Reference: Hanford Waste Vitrification Plant
DOE Contract DE-AC06-86RL10838
Fluor Contract 8457

HANFORD WASTE VITRIFICATION PLANT DESIGN CHANGE NOTICE (DCN)	DCN NO. 000016	PAGE: 1 OF 4
	DCN TITLE: DELETE PAVEMENT AND MODIFY IMPROVEMENTS FOR FAB SHOP CWBS A120, PER CR 0881	
	ORIGINATOR: H.L. Chang	DATE: 4/28/93

DESCRIPTION OF CHANGE *DELETE AND RELOCATE CONSTRUCTION OF SITE IMPROVEMENTS TO FAB SHOP PER CR 0881*

CIVIL SITE PLAN

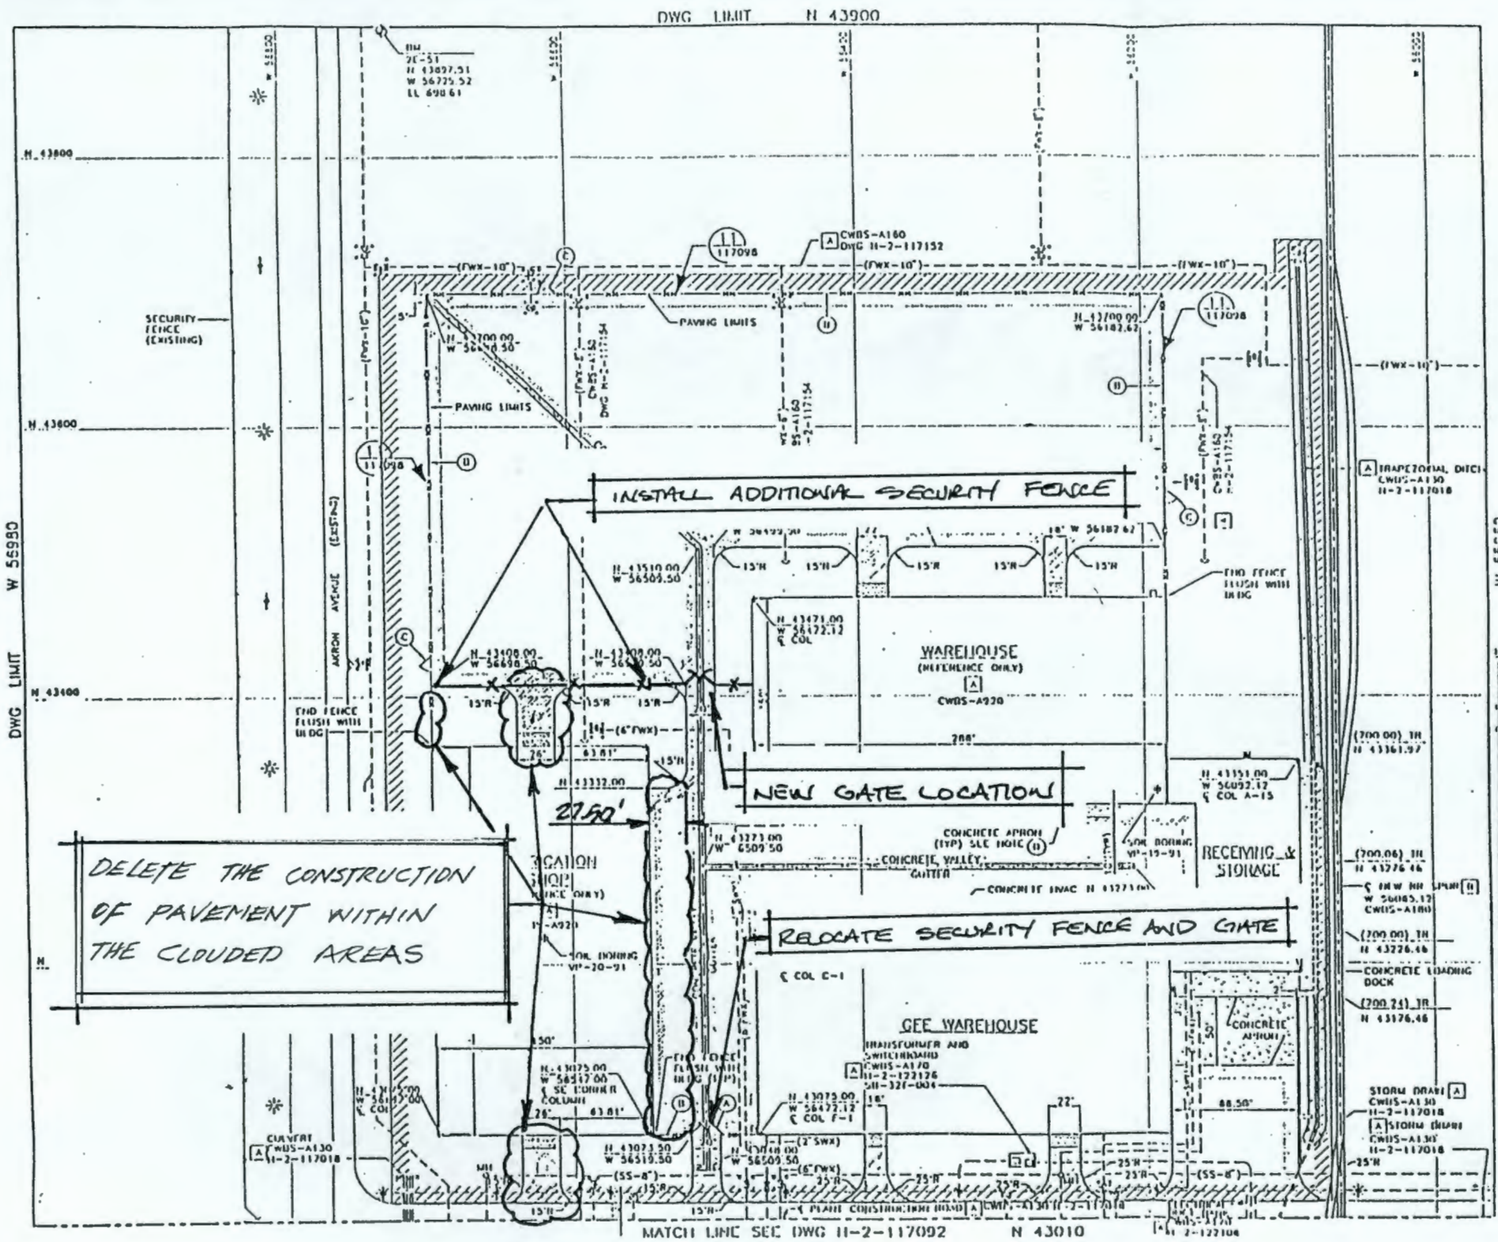
a. Delete placement of pavement and concrete aprons adjacent to Fab. Shop as delineated on page 3 attached.

b. Relocate security fence and gate between Fab. Shop and GFE Warehouse to cross driveway at coordinate location N43408 +/- per page 3 attached.

c. Install new chain link fence along edge of pavement north of Fab. Shop at coordinate location N43408 +/- per page 3 attached.

CIVIL UTILITY PLAN

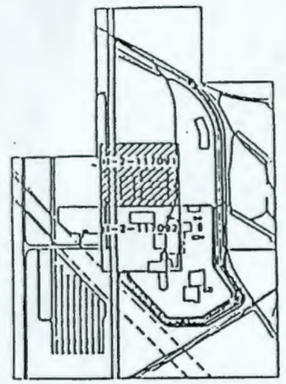
d. Delete construction of firewater (FWX) connection to Fab. Shop and connection to pipeline serving fire hydrant at southeast corner of Warehouse per page 4 attached.

e. Install new 6" diameter firewater (FWX) pipeline connecting between fire hydrant at southeast corner of Warehouse and firewater sprinkler line serving Warehouse per page 4 attached.

DELETE THE CONSTRUCTION OF FWX AND RWX LINES WITHIN THE CLOUDED AREA

NOTE: RECONNECT FIRE HYDRANT PIPING AS SHOWN
